IBC - Structural

2019 GROUP B PUBLIC COMMENT AGENDA

OCTOBER 23 - 30, 2019
RIO HOTEL AND CONVENTION CENTER
LAS VEGAS, NV

S1-19

Figure 5 - A roof slope of 1/8 in/ft provides virtually zero net slope after the roof deck assumes its allowable deflection under rain load. A 1/4 in/ft roof slope, on the other hand, leaves a net slope of 1/8 in/ft under the same condition.

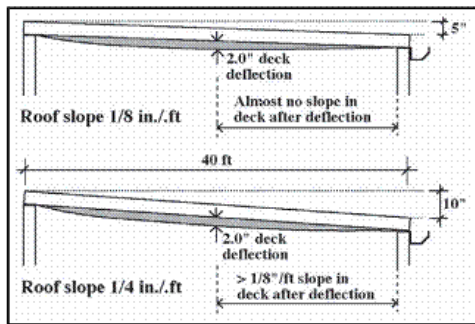
The requirement for a minimum 1/4:12 (2%) slope was added to the Codes in 1988 (Section 3207.(a) 1988 IBC). Below is an excerpt from "Life Safety Design Issues in Roofing" (Patterson, 2010) illustrating the importance of a minimum 1/4:12 slope. The slope requirements are related to the allowable deflection for roof structures. The 1/4:12 slope requirement provide a positive slope even with the maximum allowable deflection.

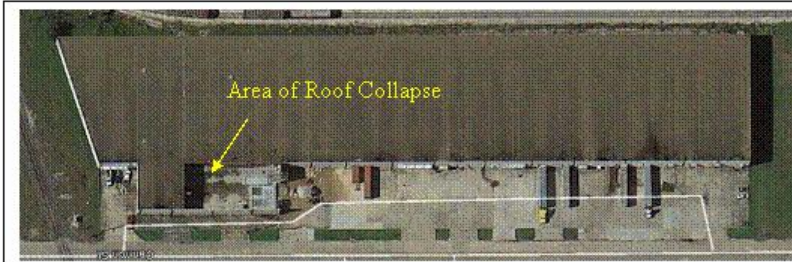
Below is an aerial photograph of a roof collapse in Houston, TX in 2013. The basic failure mode of this roof collapse was ponding instability. The roof slope was 1/8:12. There was a hail event with a large amount (several inches) of small hail that caused water to back up on the roof. There was evidence of ponding water along the edge of the roof. However, the water dried up within two days of a rain with good drying conditions, so the roof met the requirements for “Positive Drainage” as defined in the IBC.

View of roof towards collapsed area

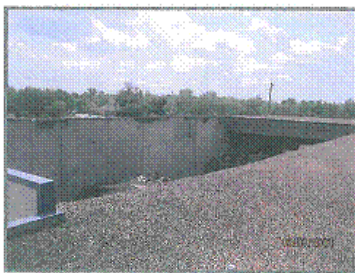
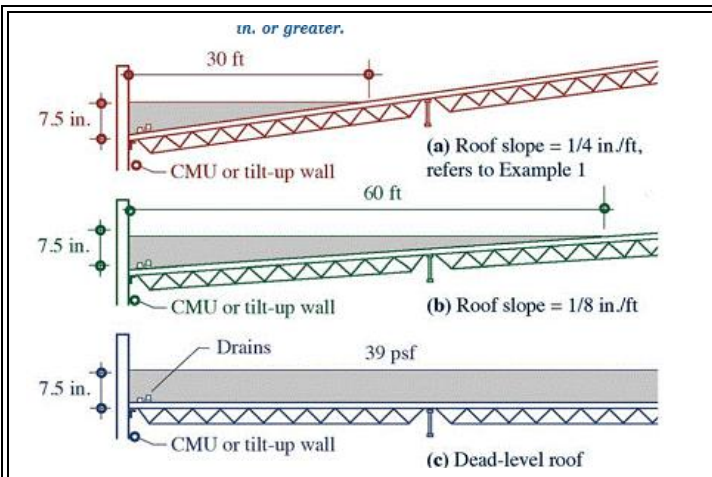
Below left is another photograph showing the same collapse shown above. Below right is a photograph (from a different roof) showing how hail blocks the flow of water on a roof and causes water to back up on the roof.

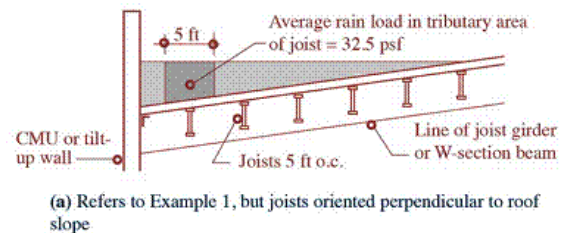
The lower the roof slope, the more water will back up on a roof and the greater the rainwater load on the structure will be. A roof with a slope of 1/8:12 backs up twice as much water as a roof with a slope of 1/4:12. Below is an excerpt from "Roof Drainage Design, Roof Collapses, and the Code" (Patterson and Mehta, 2018) showing the water distribution on a roof with different slopes.

The revised ASCE 7-16 now takes into account the structural orientation. There is much greater load on the joists if the joists are parallel to the low side of the roof than if the joists are perpendicular to the low side of the roof. Below is another illustration from "Roof Drainage Design, Roof Collapses, and the Code" (Patterson and Mehta, 2018) illustrating the ponding instability issue with joists parallel to the low side of the roof.
